**WEST VIRGINIA DEPARTMENT OF ENVIRONMENTAL PROTECTION  
WV/NPDES CONSTRUCTION STORMWATER PERMIT**

<b>FACILITY NAME:</b>	Northport Avenue Extension			<b>REG. #</b>	<b>EXPIRE DATE:</b>
<b>PERMITTEE</b>	RANSON, CITY OF			WVR110191	9/2/2020
<b>ADDRESS/PHONE:</b>	Attn: ANDREW P. BLAKE, CITY MGR 312 SO MILDRED ST RANSON, WV 25438 3047251010				
<b>LOCATION:</b>	39 22 12.95 N77 52 32.83 W			<b>Entry Date/Time:</b>	2/6/2020 @ 1103
<b>COUNTY:</b>	Jefferson			<b>Exit Date/Time:</b>	2/6/2020 @ 1224
<b>Site Representative /Phone</b>				<b>PHOTOS</b> <input checked="" type="checkbox"/>	
<b>CO-PERMITTEE:</b>				<b>ADDRESS:</b>	
<b>SITE OPERATOR:</b>				<b>ADDRESS:</b>	
<b>PERMITTED ACREAGE</b>	24.4	<b>WEATHER:</b>	Rain	<b>LAST INSPECTION:</b>	N/A
<b>RECEIVING STREAM(S)</b>	Rockymarsh				<b>NOV:</b> <b>W20-19-012-TDH</b>
<b>Regular Mail</b> <input type="checkbox"/> <b>Certified Mail</b> <input checked="" type="checkbox"/>		<b>Tracking #</b> 70192970000166130895			
<b>OVERALL FACILITY RATING:</b>	<b>Unsatisfactory</b>		<b>COMPLIANCE OUTCOME</b>	<b>Not Immediately Corrected</b>

STATE OF WEST VIRGINIA  
Department of Environmental Protection  
Environmental Enforcement  
NOTICE OF VIOLATION

Viol

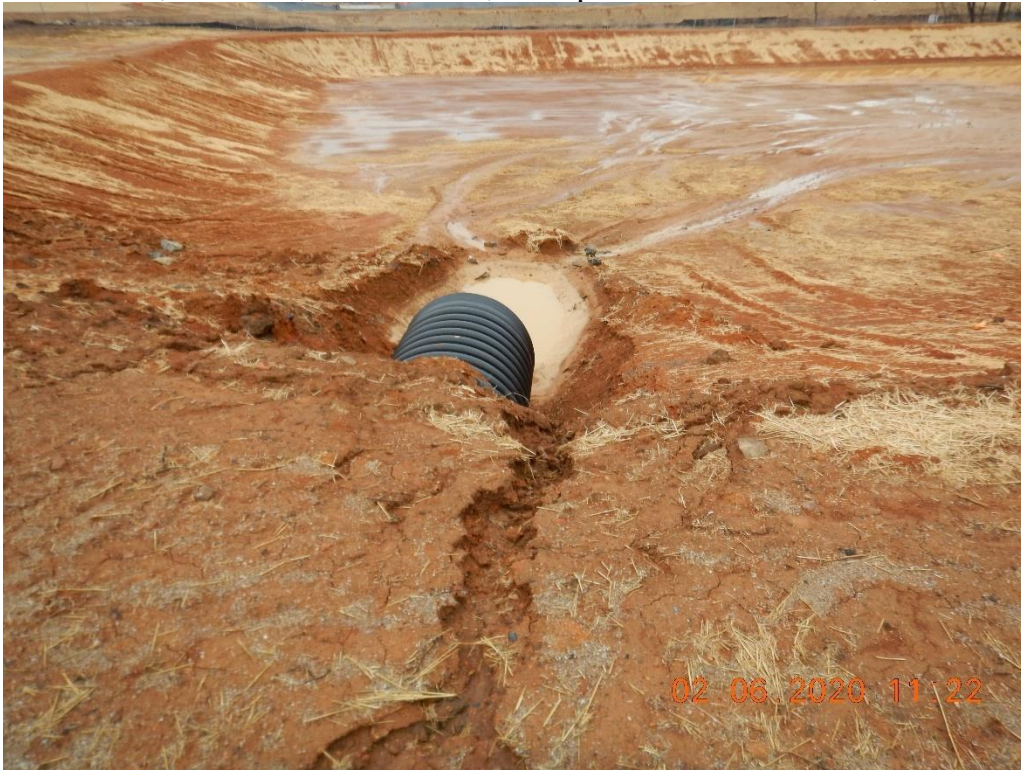
Perimeter controls are not properly installed, there are many areas where the toe of the silt fence was not toed in correctly and many panels of silt fence were not conjoined correctly as indicated in the plan details on sheet 19.

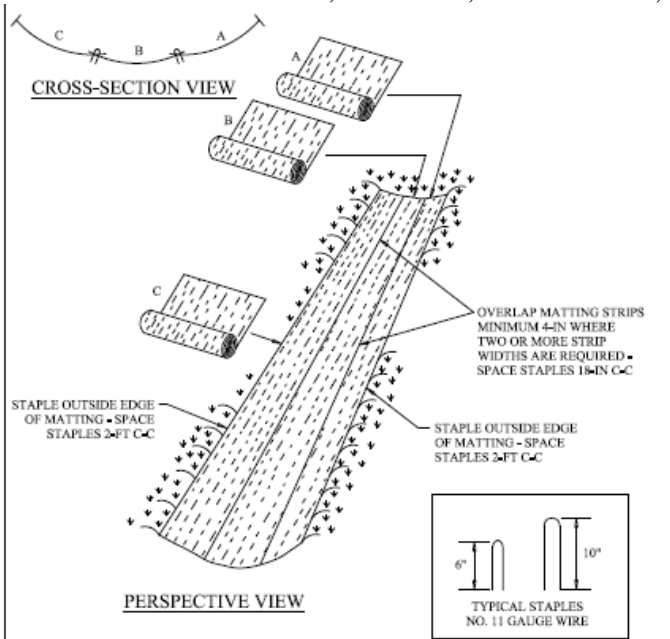
Sediment laden water coming out of sediment basin outfall.

**EROSION CONTROL MATTING DETAIL**  
NOT TO SCALE

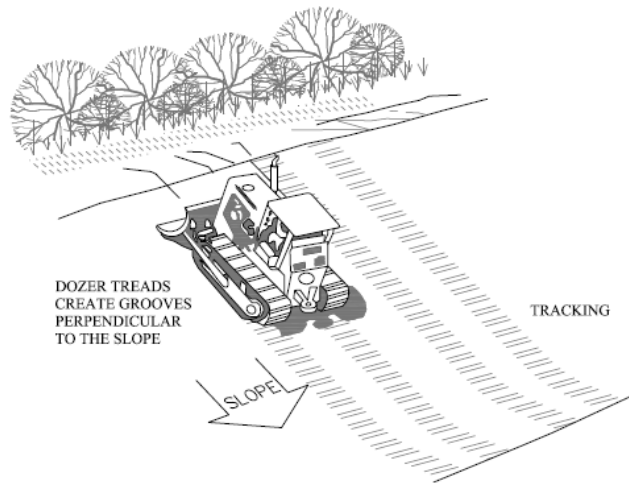
Diversion channel not installed per plan sheet details with ECM and rock check dams.

**TRACKING A CONSTRUCTED SLOPE**  
NOT TO SCALE

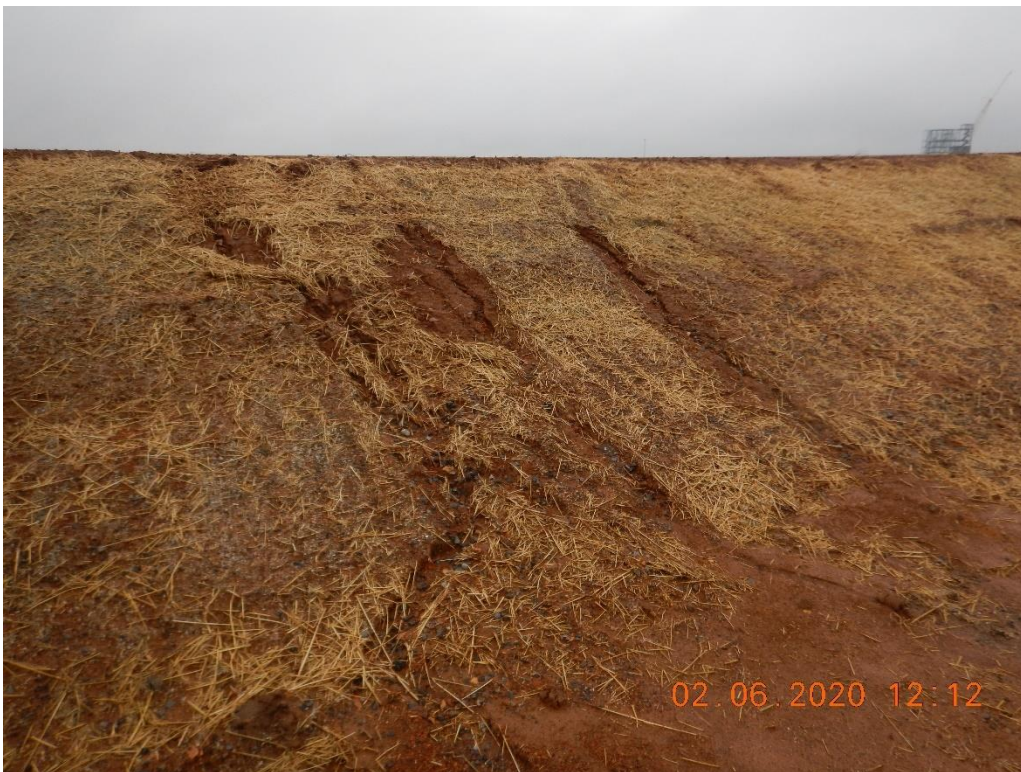
Improperly tracked in constructed slopes are aiding in the development of erosion rills to form on fill slopes that are found throughout the project site.
